**MINERALS PROGRAM INSPECTION REPORT**  
**PHONE: (303) 866-3567**

<b>MINE NAME:</b> Cresson Project	<b>MINE/PROSPECTING ID#:</b> M-1980-244	<b>MINERAL:</b> Gold	<b>COUNTY:</b> Teller
<b>INSPECTION TYPE:</b> Monitoring	<b>INSPECTOR(S):</b> Brock Bowles	<b>INSP. DATE:</b> March 2, 2022	<b>INSP. TIME:</b> 09:45
<b>OPERATOR:</b> Cripple Creek & Victor Gold Mining Compar	<b>OPERATOR REPRESENTATIVE:</b> Katie Blake	<b>TYPE OF OPERATION:</b> 112d-3 - Designated Mining Operation	
<b>REASON FOR INSPECTION:</b> Normal I&E Program	<b>BOND CALCULATION TYPE:</b> None	<b>BOND AMOUNT:</b> \$209,491,188.00	
<b>DATE OF COMPLAINT:</b> NA	<b>POST INSP. CONTACTS:</b> None	<b>JOINT INSP. AGENCY:</b> None	
<b>WEATHER:</b> Clear	<b>INSPECTOR'S SIGNATURE:</b> 	<b>SIGNATURE DATE:</b> April 8, 2022

Photo 2 – ECOSA seep pond on west side of access road, facing south

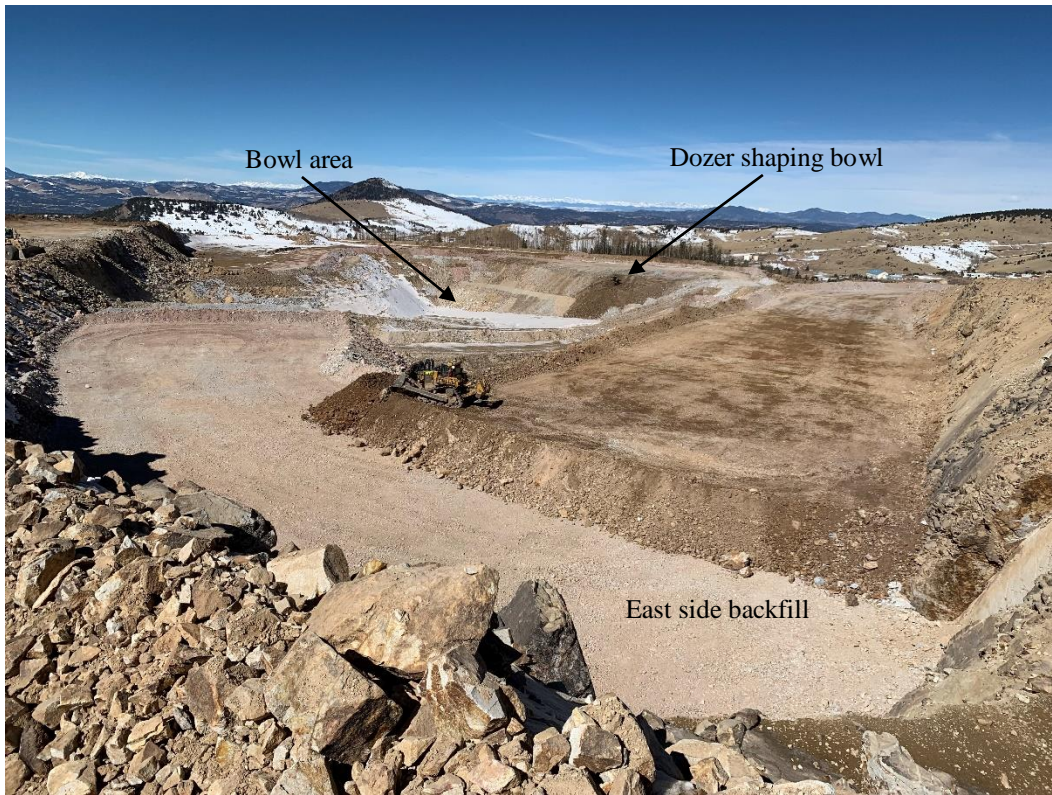
The area is being backfilled to stabilize the toe of the slope. The material being used to backfill is from non-ore processing projects on-site. The area has been graded and sloped to the north (photo 1). The runoff is directed to a large pit on the east side of the access road. The rills and gullies on the reclamation above the clay borrow area have not been repaired. A consultant has been hired to investigate the causes and come up with a new design for the reclaimed area. There is no estimated timeline as to when the repair work will happen. The spring pond was frozen, snow covered and appeared to be very low (photo 2). No discharge was noted and a pump was onsite.
